**Meeting of the Central Valley Flood Protection Board
July 26, 2013**

Staff Report – Encroachment Permit 18834

**Brent Barton
Barton Ranch Creek Crossing, San Joaquin County**

EXHIBIT A

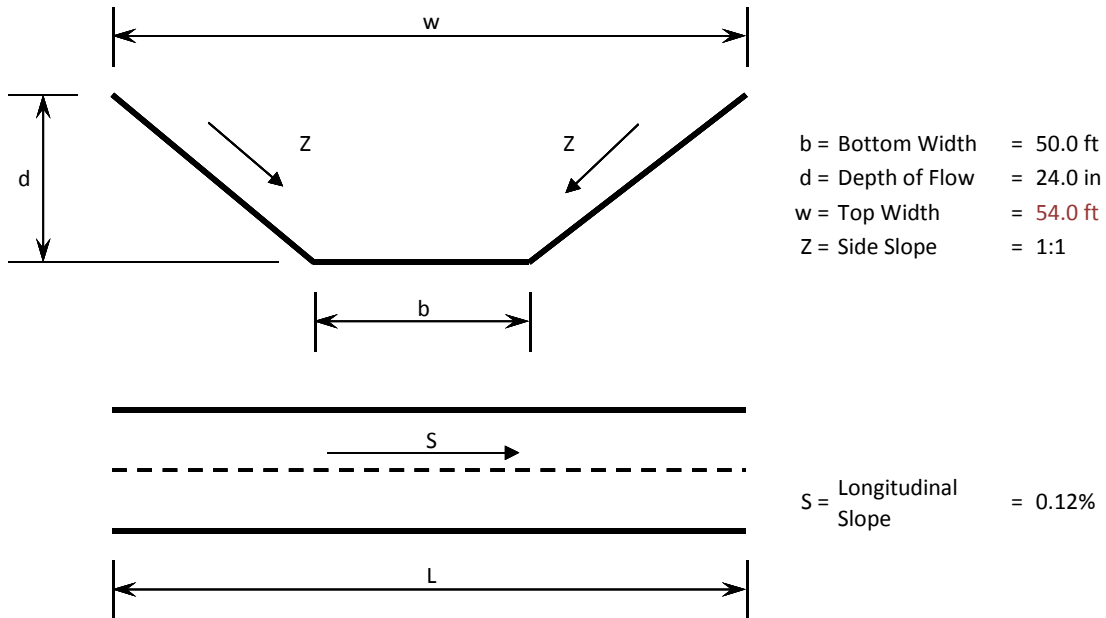
2. Provide justification that this project will not result in any adverse hydraulic impact, that the post-project conditions will not be worse than the existing conditions.

3. Provide justification that these culverts will pass the existing design flow without creating tail-water effects that will inundate adjacent properties.

100 YR CHANNEL FLOW EVENT
